SHORE POINT ARCHITECTURE, PA

RESPONSE TO “INCOMPLETE” ITEMS

Date: May 31, 2024
SPA Job Number: 2023-21 (Stone Residence)
Property Address: 14 Abbott Avenue, Ocean Grove (Block 247, Lot 3)

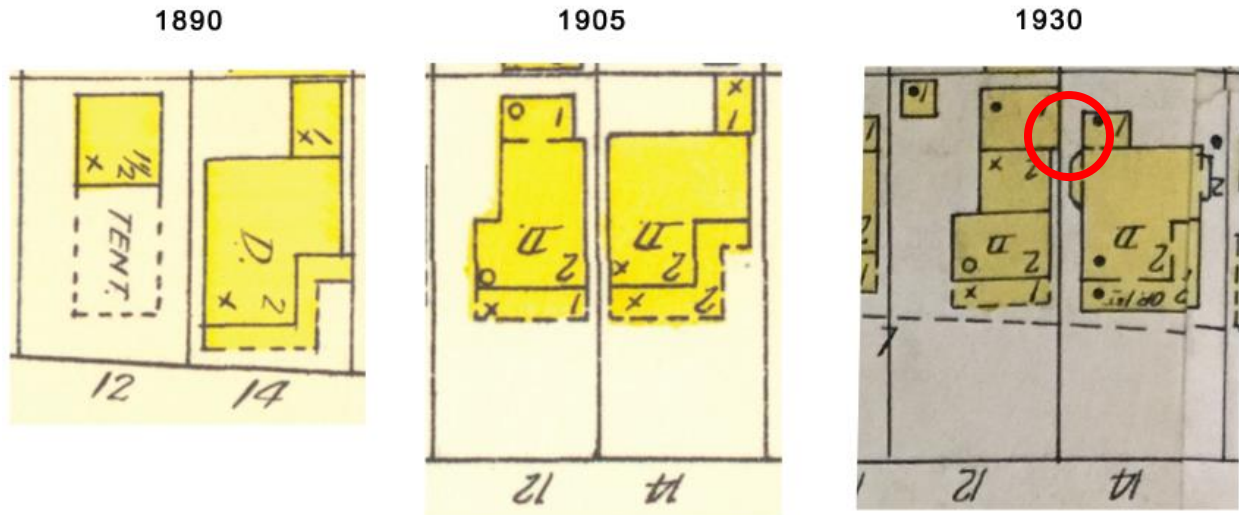
HPC Item #5: Demo 2nd story bay on west elevation. Please provide information about whether this bay is historic or part of an earlier addition. Request for more information.

SPA Response: The second-floor “box bay” was an addition constructed over top of a first floor pre-existing “angeled” bay style bump out which itself may or may not be original when you compare its size, shape and location to the Sandborn map provided. Both bays were likely once in the location of a wrap around porch (re: sanborn). The framing style (studs on the flat) and sheathing materials of the second floor “box bay”, is not consistent with the few existing historic areas of the home. The fact that both from the inside and outside the first floor tin roofing still present shows that the second floor bump out was added at a later time. Pictures provided:

- (a) Roofing occurs between the first and second floor addition, suggesting the second floor addition occurred after the first floor addition.
- (b) Inside of the bump out (facing north) was cut in later, as shown by the clapboard in the wall.
- (c) Inside of the bump out (facing south) was cut in later, as shown by the clapboard in the wall.
- (d) Framing on flat bump out cut into existing framed wall, with sheathing and metal framed roof.

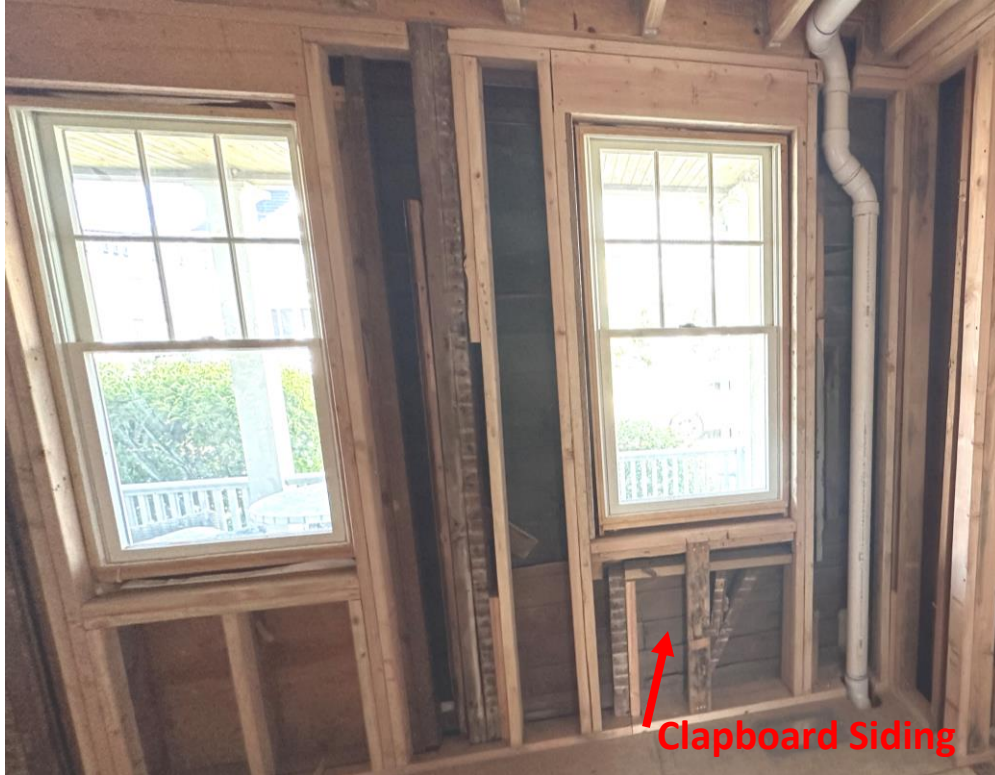
HPC Item #6: (a) Demo existing 2nd floor uncovered Juliet balcony at south elevation and extend the existing shed roof. Roof to have a rolled roof cladding. Please provide information about whether this balcony is historic or part of an earlier addition. **(b)** Also, please specify the color the proposed rolled roof. Request for more information.

SPA Response: (a) Per the Sanborn maps provided, the Juliet balcony exists in an area that was historically an open alleyway (circled in red, below), therefore it is not original or historic. It was likely constructed when the houses were joined, sometime in the 1990's.

**Closing of First and Second Flor North/West Wrap Around Porches
(Plywood Sheathing)**

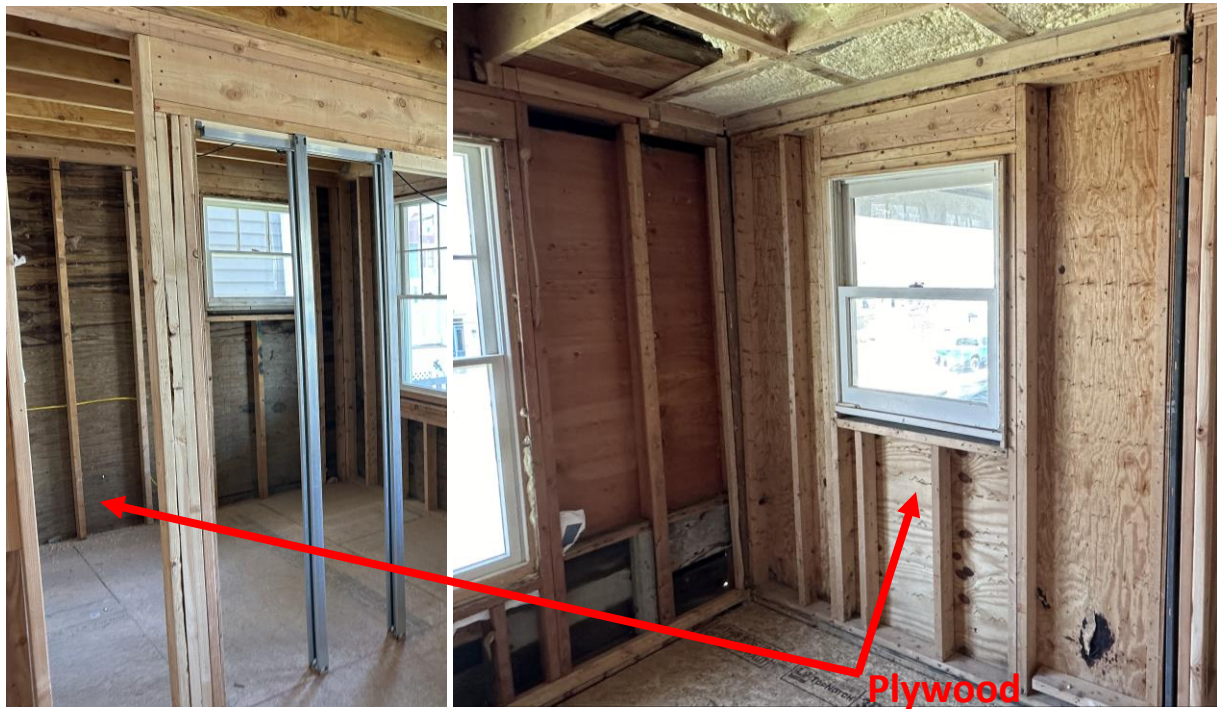
HPC Item #11: Install Eastern white cedar shingle, 5" exposure, straight bottom, cladding on the entire house. A historic photo in the file suggests the original cladding was of shingles with variable exposure (as seen on an existing portion of the dwelling.) Please modify the drawings to reflect this historic cladding pattern and update the narrative. Heather: Please send Andrea a copy of the photos in the file.

SPA Response: The house identified as #14 on the Sanborn map currently has standard pattern cedar shake on the front and rear façade and variable pattern shake on the west side façade only. The shake on the front and rear façade was done in the 1990's when the houses were joined together. The variable pattern shake on the west side was done earlier than that most likely in the 50's, 60's or 70's and is not the original siding on the house. The original siding on the house was clap board and approximately 50% is still present below the cedar shake on all 3 sides and can be seen throughout since the house was gutted. The existing clap is in non-salvageable condition. The areas that were modified over time which are the closing of the first and second floor north/west wrap around porches, the west side first and second floor bump outs referenced in item#5, the change of roof line in the south/west corner, third floor dormer, second floor newly created porch entry and the first floor rear addition with a shed style roof have either plywood sheathing or individual 1x6 or 1x4 slat sheathing. Pictures provided. The house identified as #12 on the Sanborn map currently has standard pattern cedar shake on the front, rear and east façade. The shake on the facades was done in the 1990's when the houses were joined together which is evident by the amount of design changes to the structure and the presence of plywood sheathing under all shake except (1) approximately 7'x 8' area on the second floor east side which appears to be the original siding which is a combination of 1x8 vertical board and 1 x 4 horizontal board. The variable pattern shake that is shown in the series of pictures (pictures from 70's or 80's) provided to SPA and J.Urig Contracting was most likely done in the 50's 60's or 70's and was not original. Pictures provided.
